ADDENDUM NO. 2

September 9, 2022

CROWN POINT HIGH SCHOOL ATHLETIC FIELDS AND SITE IMPROVEMENTS
Crown Point, IN 46307

ADDENDUM TWO

SHEET
S-100N

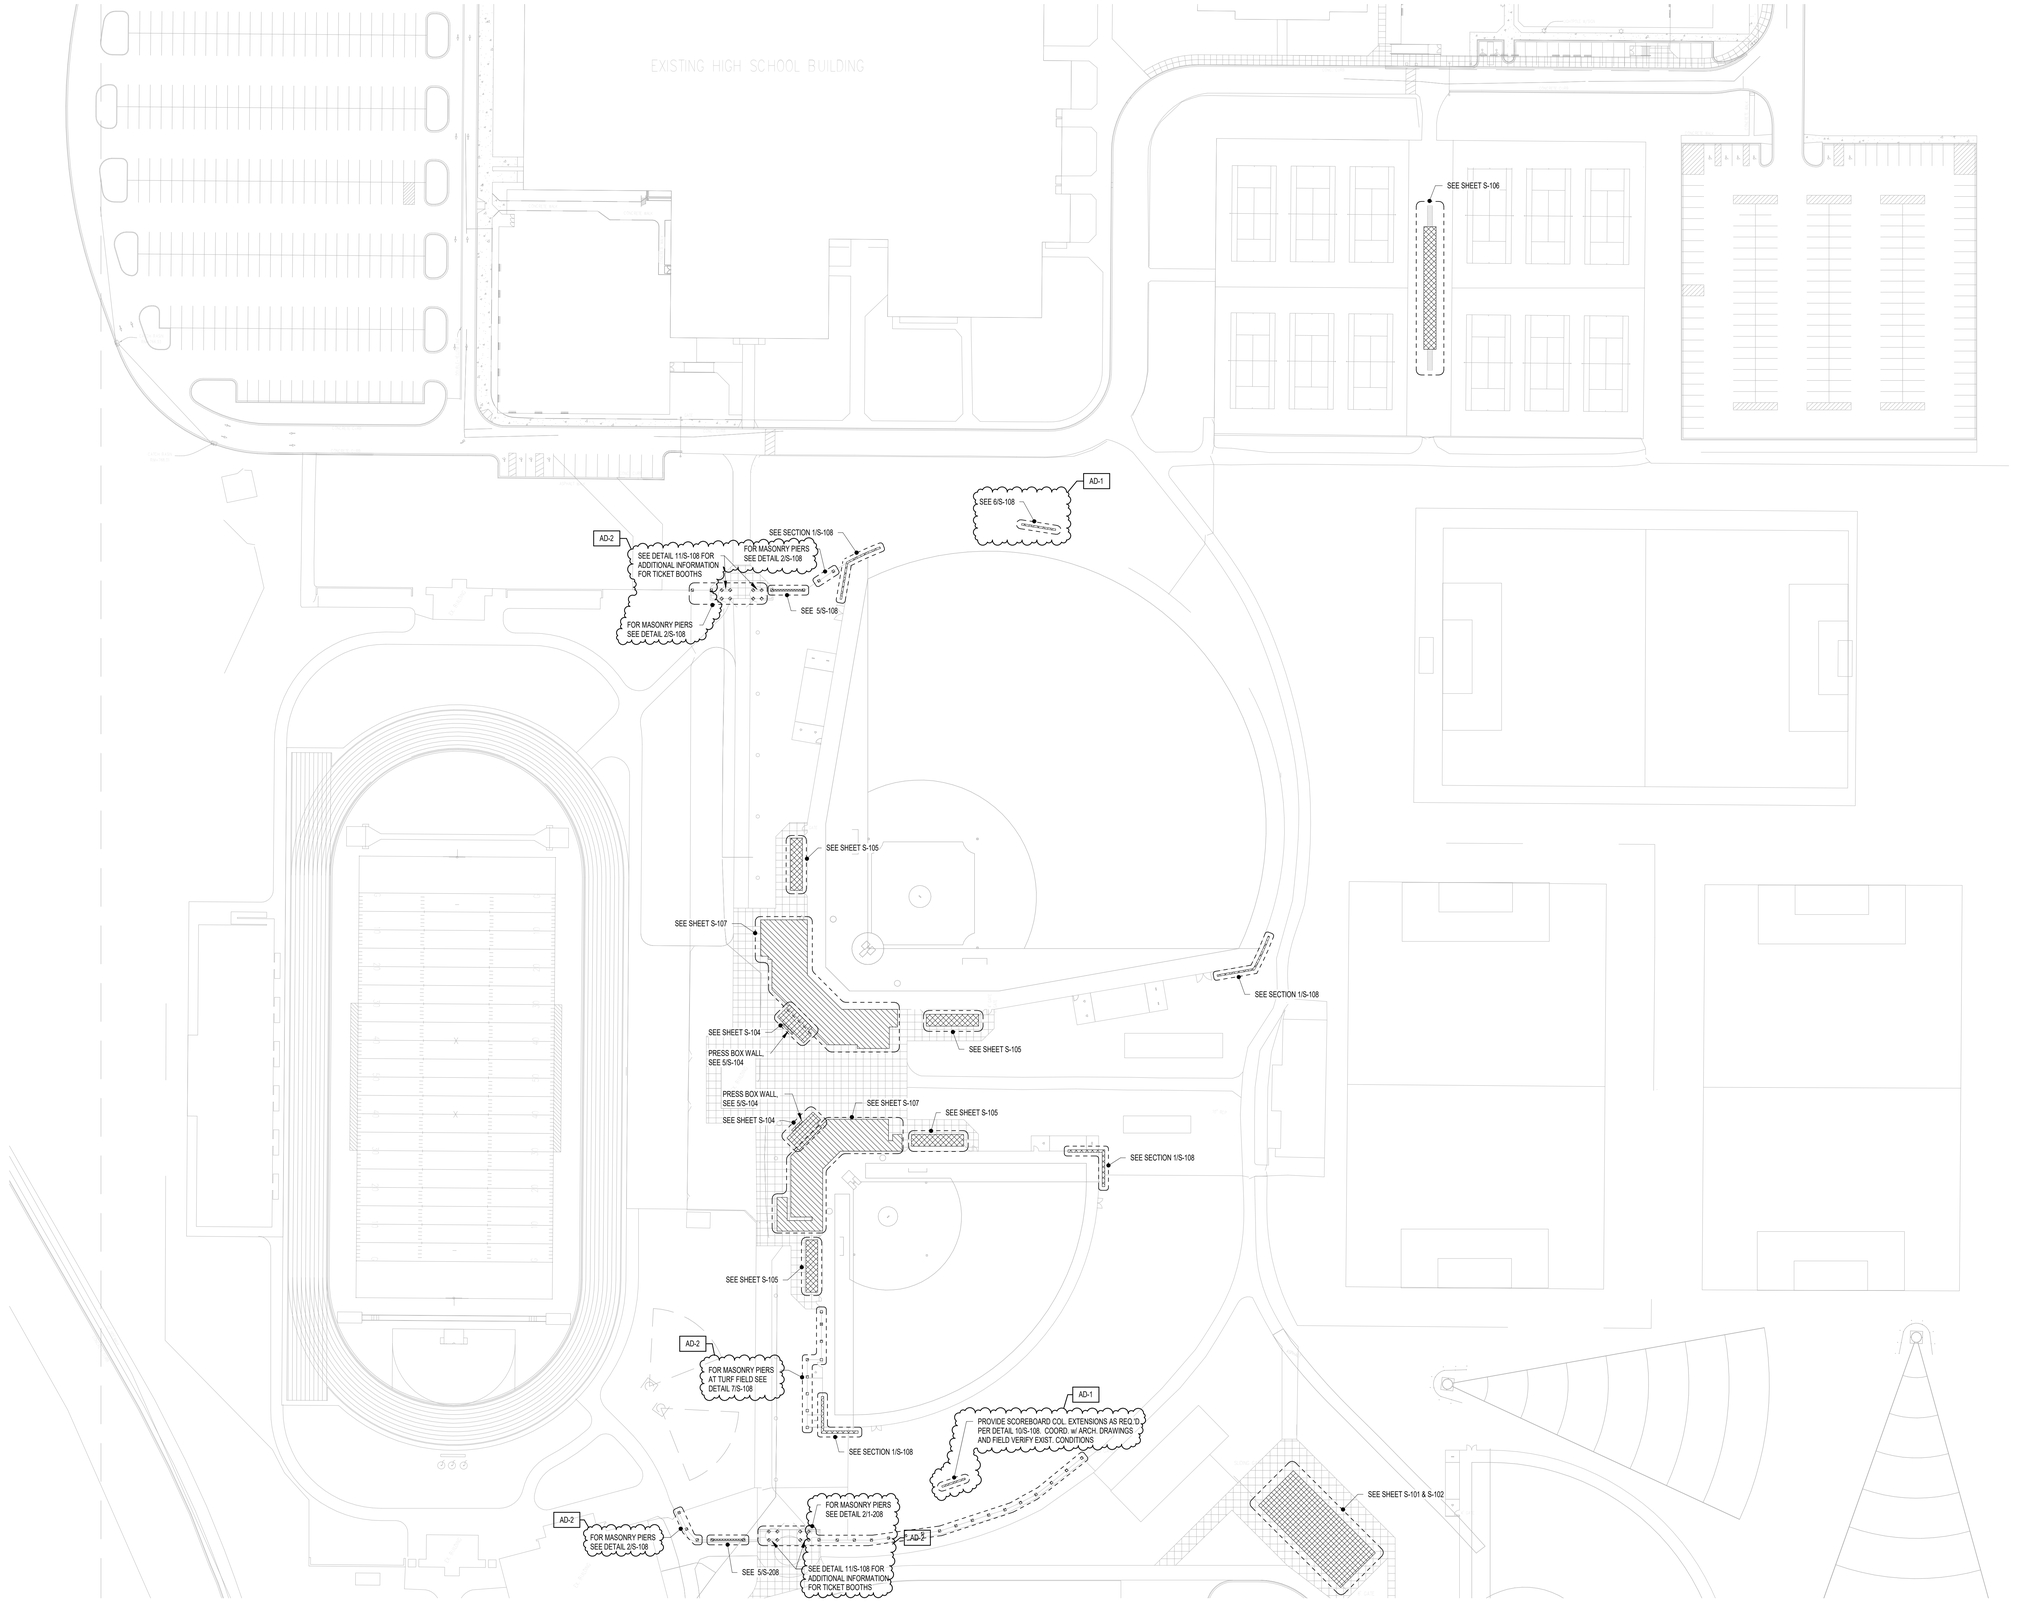
10. Sheet S-100N and S-100S

A. Refer to two (2) revised, full-size drawings, included in this Addendum, for the following revisions:

1. Updated references to ticket booths added.
2. Masonry pier detail references corrected.

SHEET
S-101

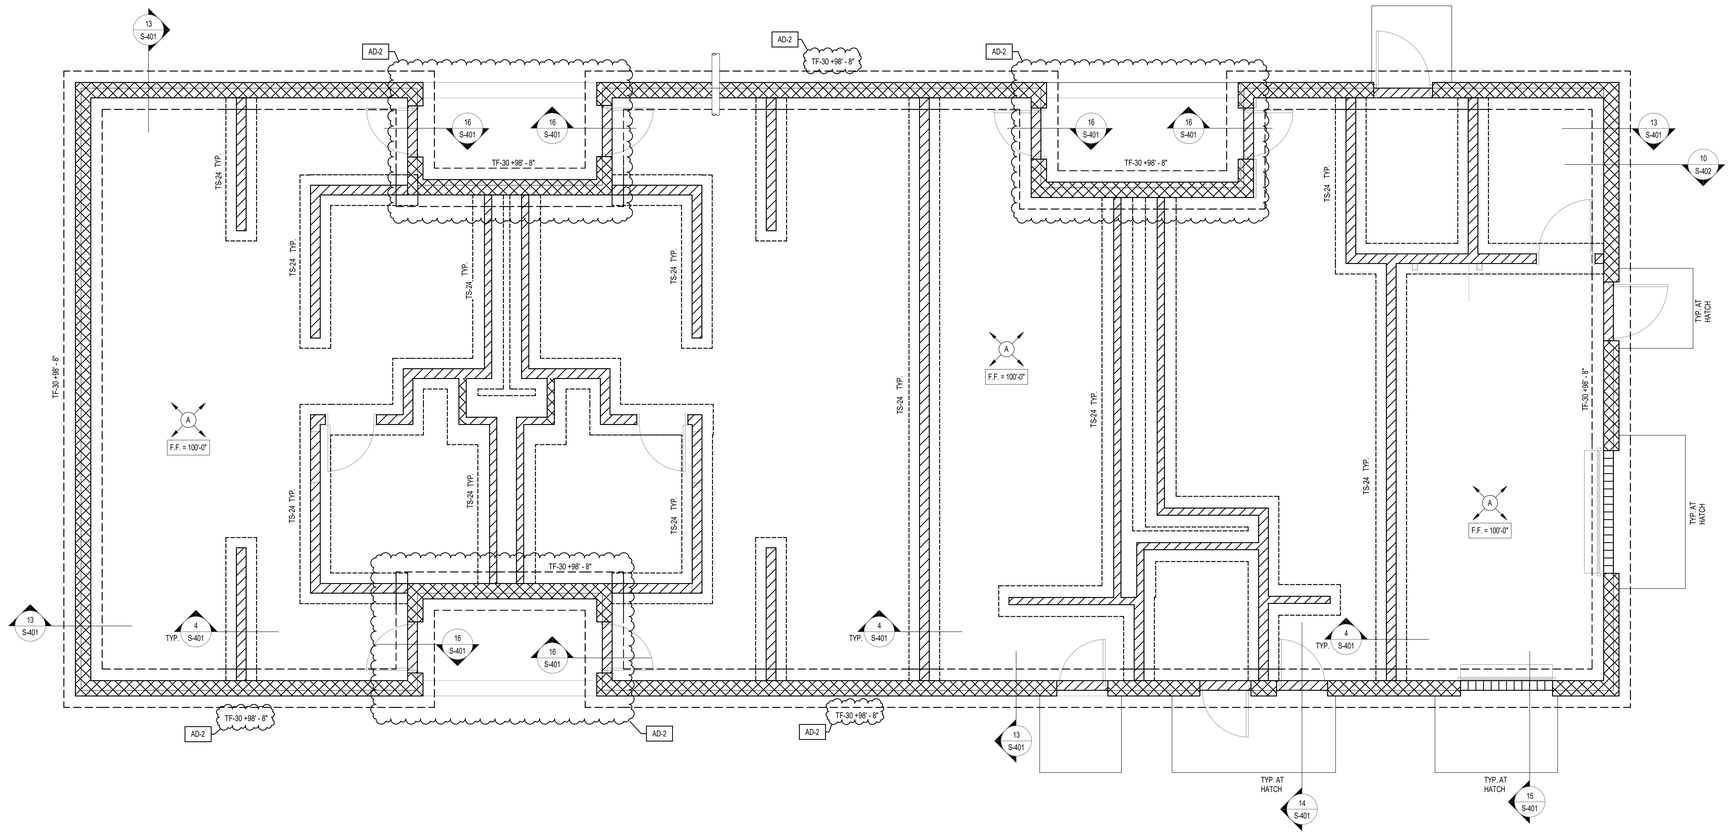
11. Sheet S-101

A. Refer to revised, full-size drawing, included in this Addendum, for the following revisions:

1. Void slabs at entry alcoves removed. Section added for entries.
2. Trench footing labels added, along with trench footing schedule.

SHEET
S-102

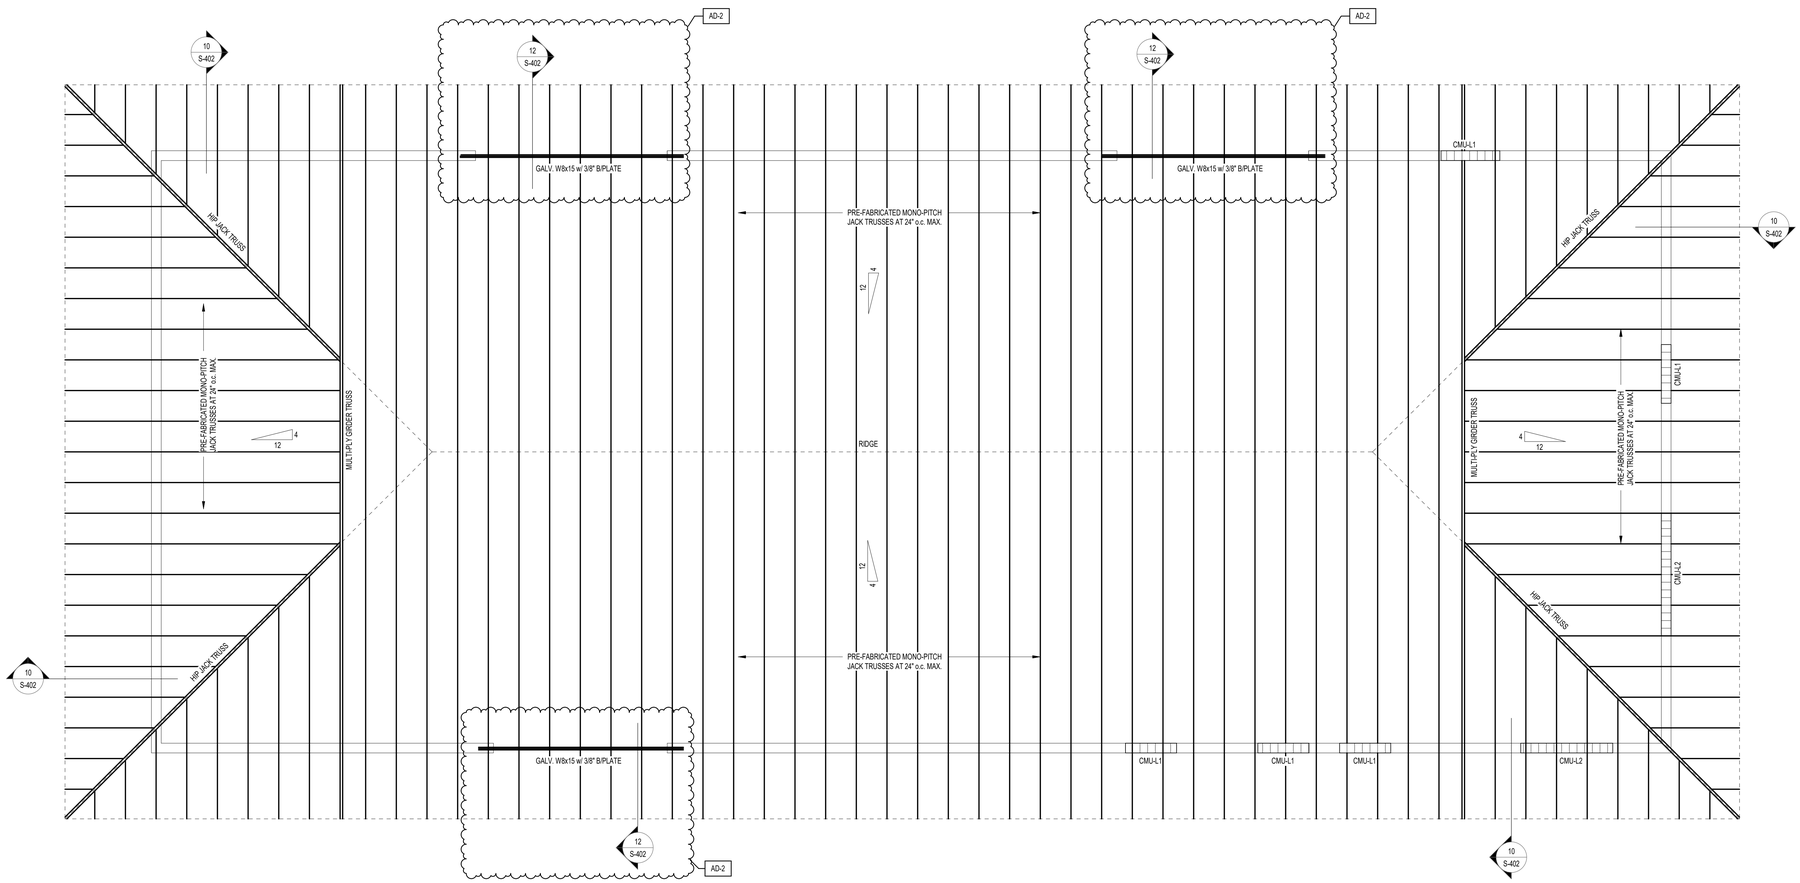
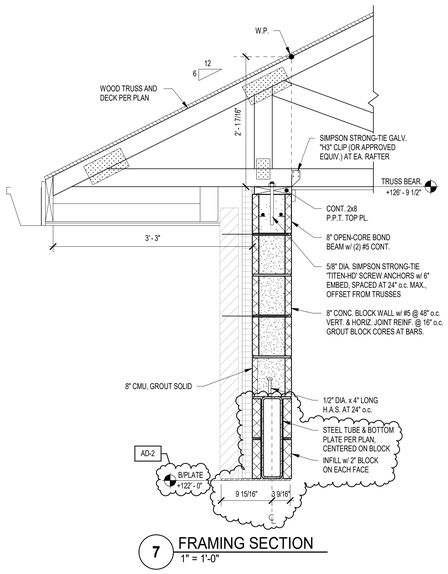
12. Sheet S-102

A. Refer to revised, full-size drawing, included in this Addendum, for the following revisions:

1. Lintels noted to be galvanized.
2. Section at lintels added

1. Detail 6 – Post anchorage notes updated.

SHEET
S-104

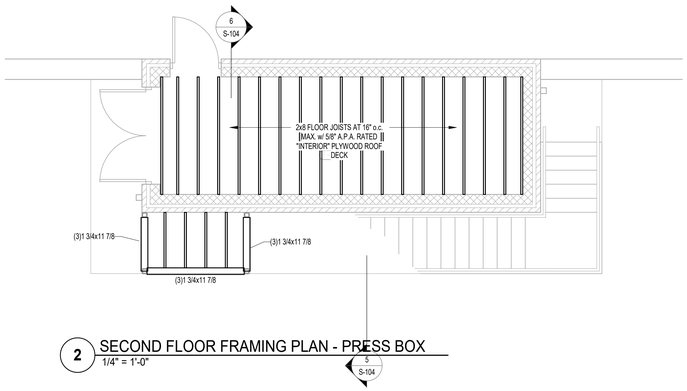
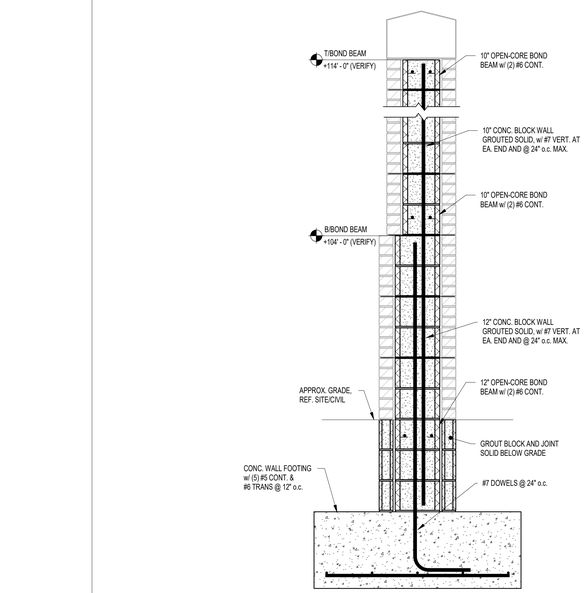
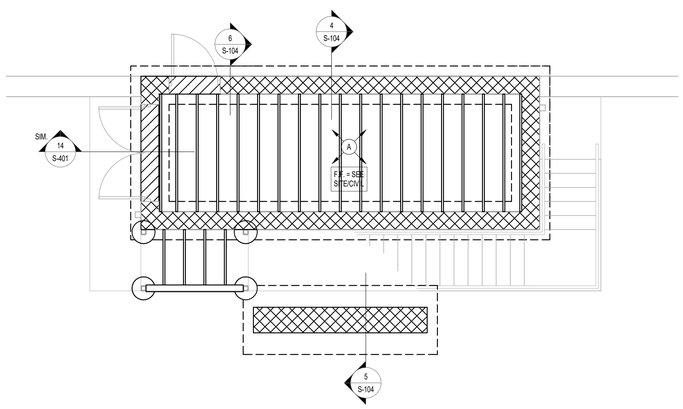
13. Sheet S-104

A. Refer to revised, full-size drawing, included in this Addendum, for the following revisions:

1. Detail 4 – Trench footing reinforcing defined.
2. Detail 7 – Lintel and plate size added.

SHEET
S-105

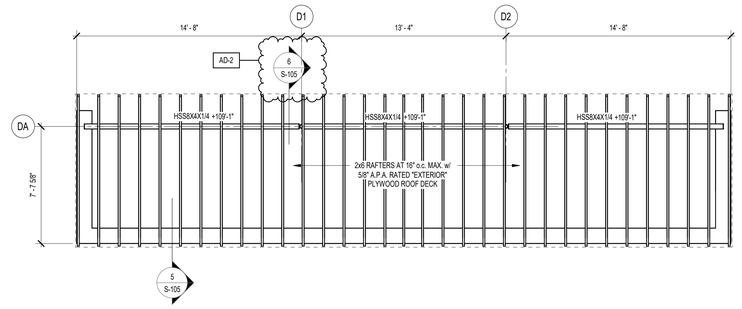
14. Sheet S-105

A. Refer to revised, full-size drawing, included in this Addendum, for the following revisions:

1. Column footing schedule added to foundation plan
2. Section at high eave of roof framing added.

SHEET
S-108

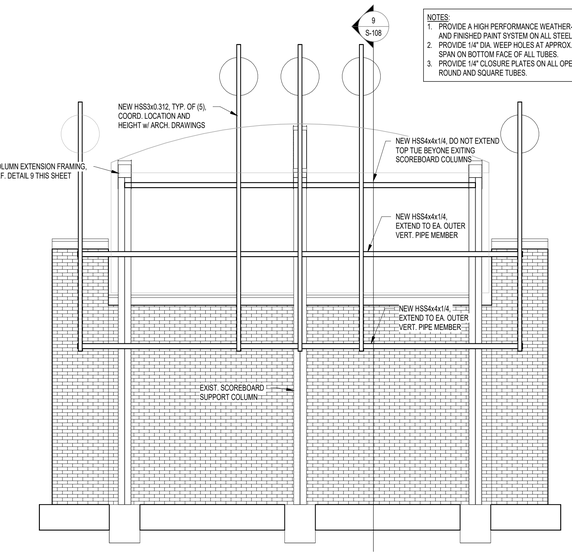
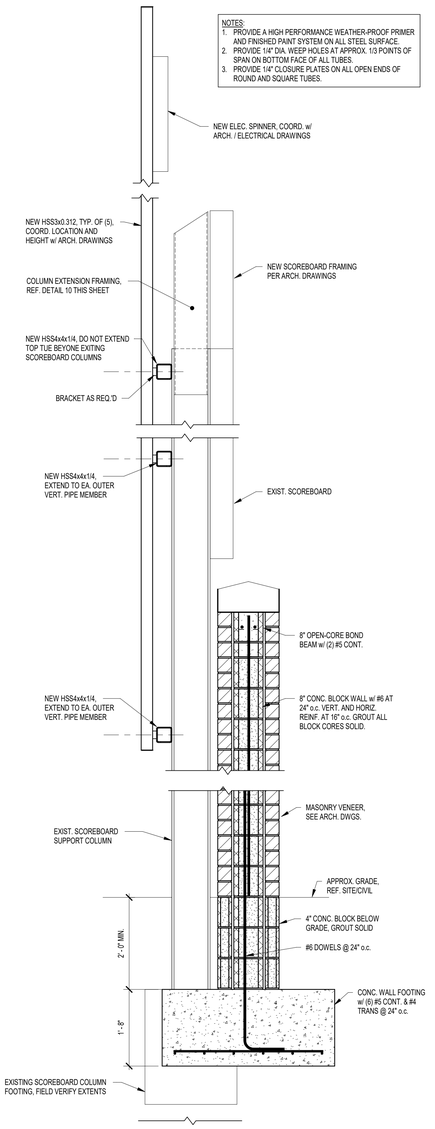
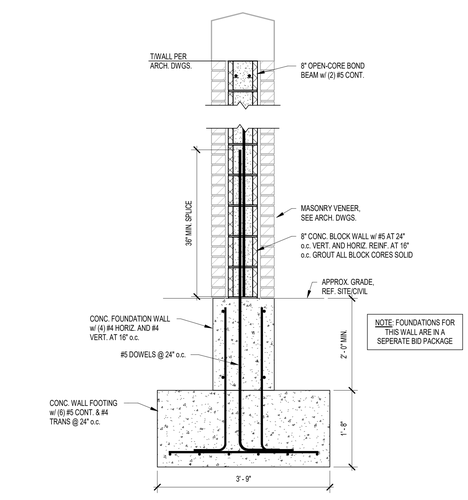
16. Sheet S-108

A. Refer to revised, full-size drawing, included in this Addendum, for the following revisions:

1. Structural plan for Ticket Booths added.
2. Foundation section at front wall of Ticket Booths added.
